Proposal to make Energy detect more robust in 10GBASE-KR EEE mode.

Velu Pillai
17th November, 2009

CL49 LPI transmit state diagram changes (Fig 49-16)

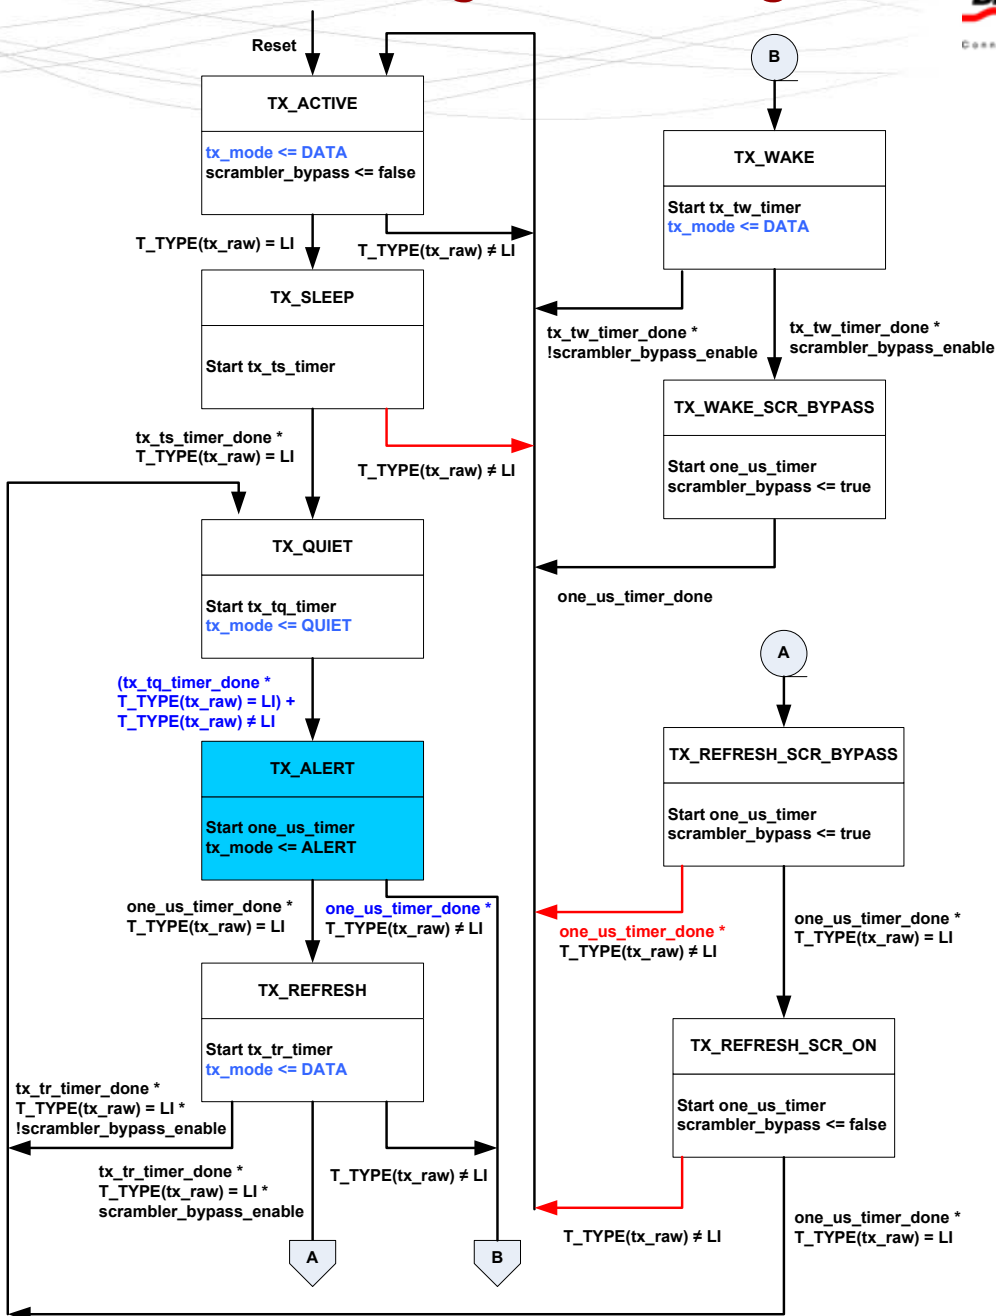
- Solutions to the bugs in the Fig 49-16 (Draft 2.1). Comments are filed against these.

- Changes needed for alert pattern.
